APPLICANT : CEMEX (ROI) LTD

**WL0254-01 - Article 16(1)
Further Information Response
- Walshestown Co. Kildare**

ARTICLE 16(1) RESPONSE

Drawing No. WLA-16 Rev. D – Emissions to groundwater and groundwater monitoring points

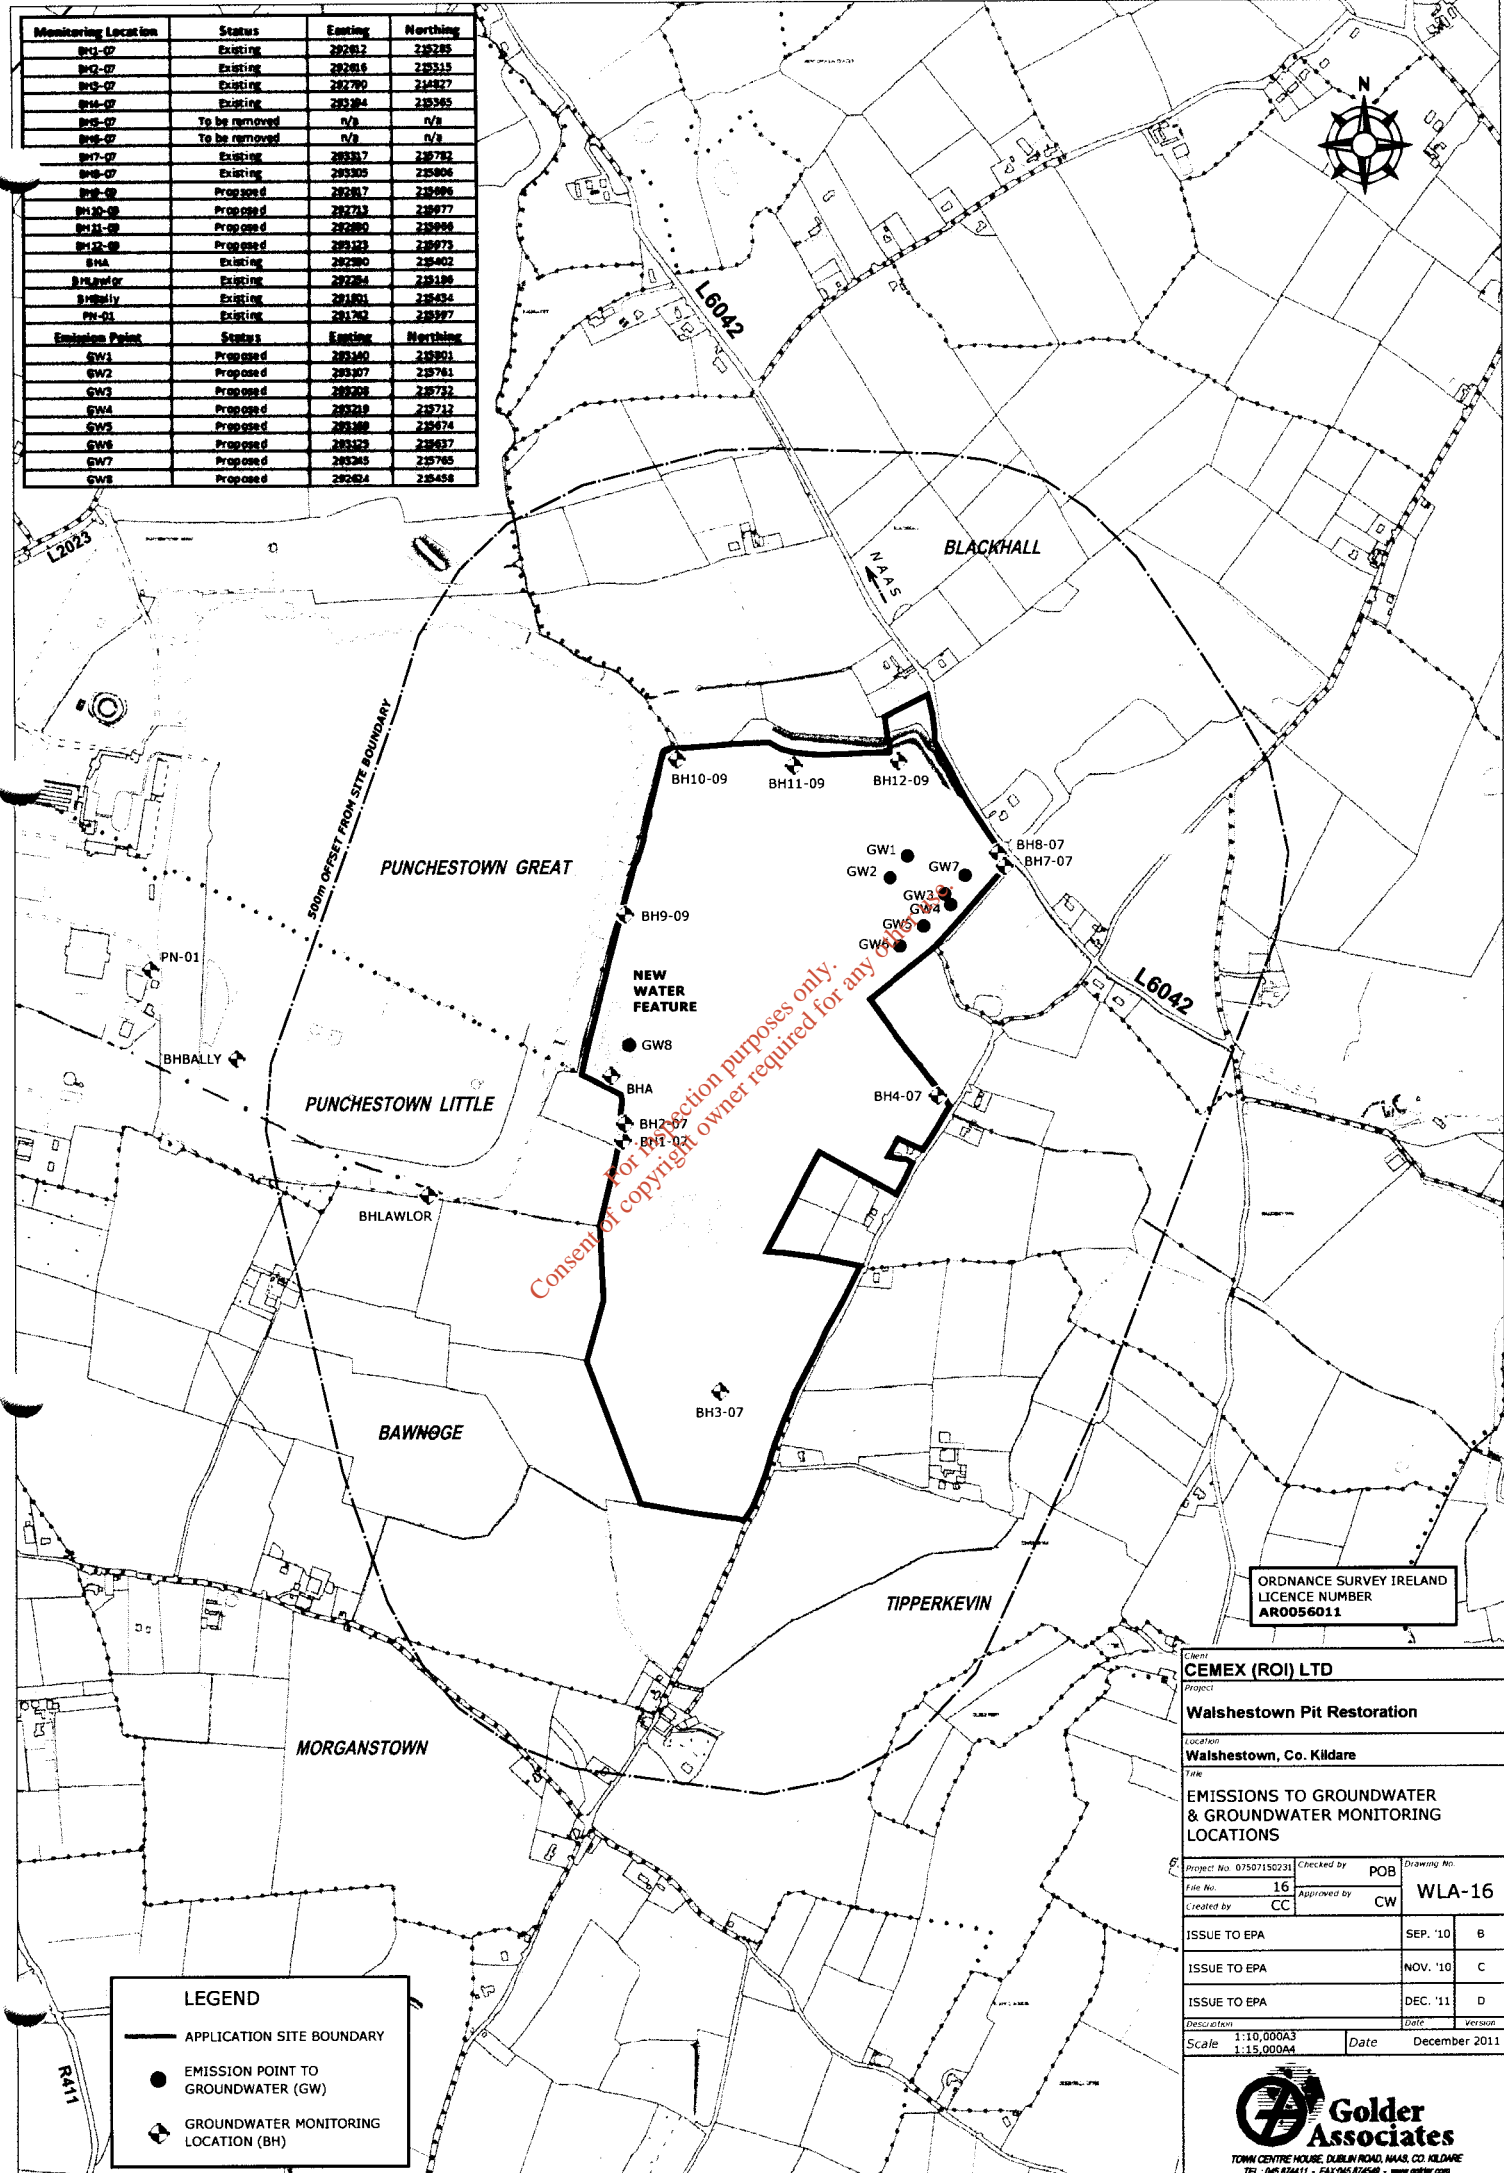
"Provide a drawing showing the borehole and irrigation supply for the Punchestown racecourse is supplied from. Provide a symbol for this borehole."

"Clarify the location of emission to groundwater GW8 and groundwater monitoring borehole BHA. Explain how GW8 and BHA will be monitored. State if boreholes BH9-09m BH10-09, BH11-09 and BH12-09 have already been constructed. Also provide a date for removal of boreholes BH5-07 and BH6-07."

"Provide a drawing showing clearly all emissions to groundwater and groundwater monitoring locations. Use different symbols for emission points and monitoring locations. If there have been any new emissions points or monitoring locations installed provide their description and grid reference numbers".

It is understood that Punchestown Racecourse takes irrigation supply water from a borehole located on their lands, as highlighted in Drawing WLA-16 (Rev. D) attached in **Appendix 11**. This borehole has been given the symbol PN01.

Groundwater monitoring location GW8 is located within the New Water Feature (at the edge of this feature), as this water feature will be an expression of groundwater (Drawing WLA16 Rev. D, **Appendix 11**). This is a proposed groundwater monitoring location, and will be sampled using a surface water grab sampler. BHA is an existing groundwater monitoring location and is located towards the southern edge of the New Water Feature (**Appendix 11**). This monitoring location will be sampled using traditional groundwater sampling techniques such as a bailer, waterra tubing or sampling pump.

Drawing No. WLA-16 Rev. D in **Appendix 11** of this document provides details on all groundwater emission points and monitoring locations, both existing and proposed. Below is a detailed list of these points and locations, their current status and GPS co-ordinates.

Drawing No. WLA-18 Rev. A – Emissions to surface water and surface water monitoring points

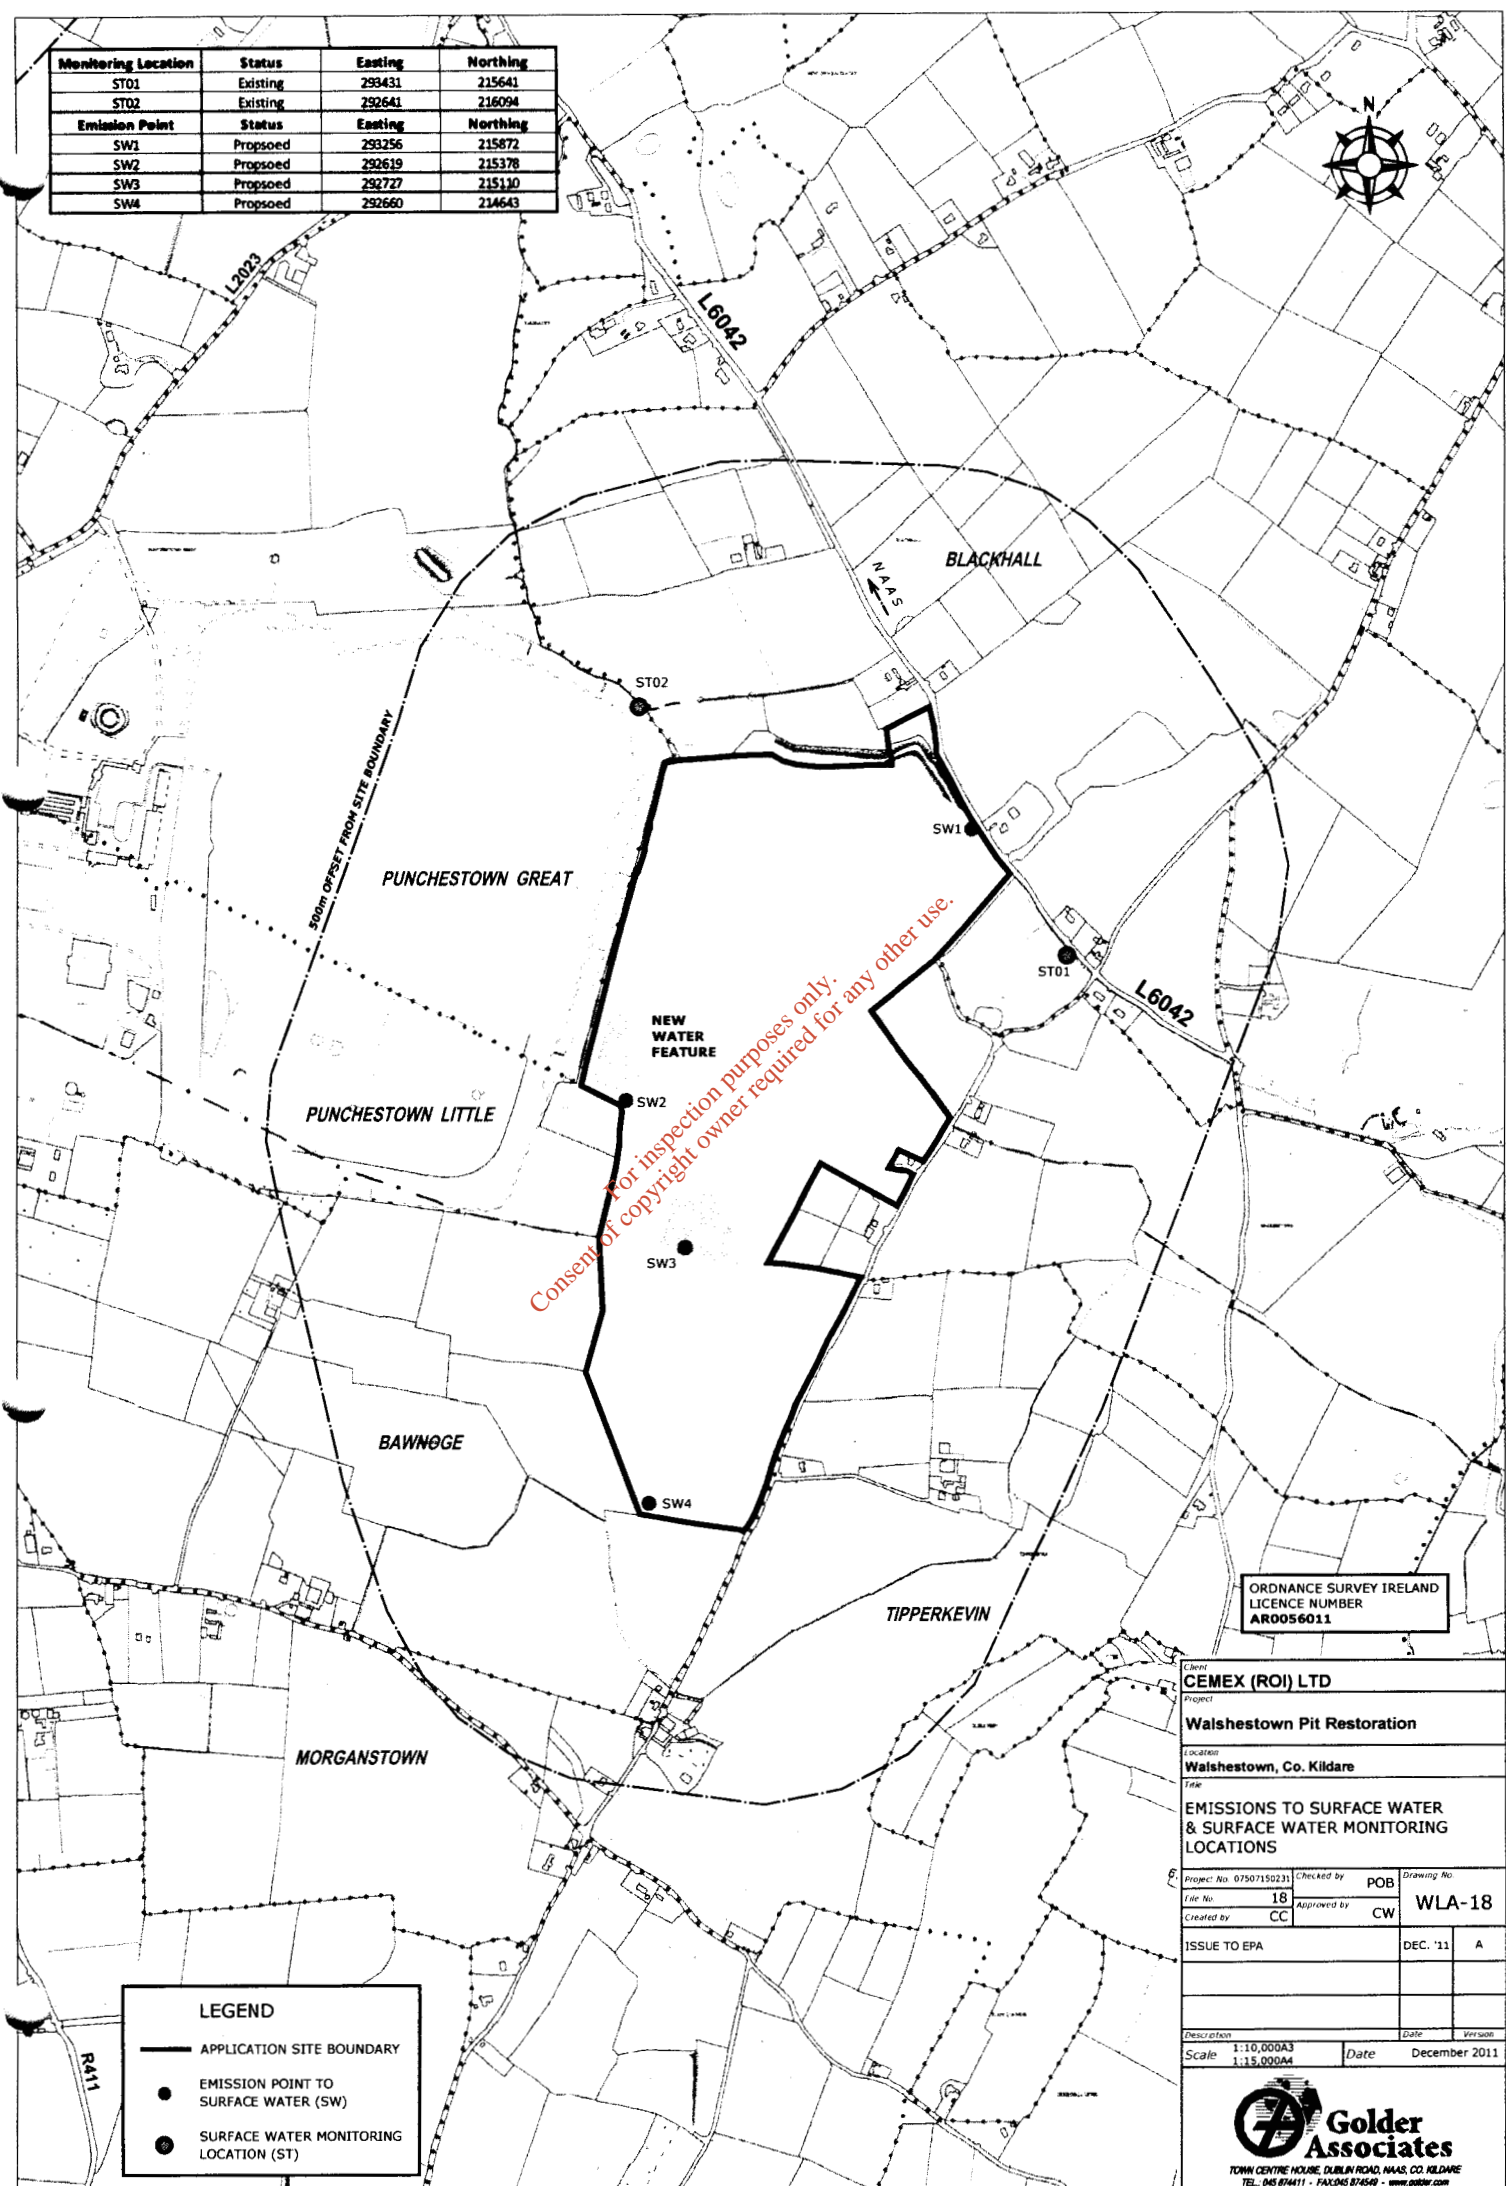
"Provide a drawing clearly showing all emissions to surface water and surface water monitoring locations. Use different symbols for emission points and the monitoring locations. If there have been any new emission points or monitoring locations installed provide their description and grid reference numbers. Describe compliance with the Environmental Objectives (Surface Waters) Regulations, 2009."

Drawing No. WLA-18 Rev. A in **Appendix 12** of this document provides details on all surface water emission points and monitoring locations, both existing and proposed. Below is a detailed list of these points and locations, their current status and GPS co-ordinates.
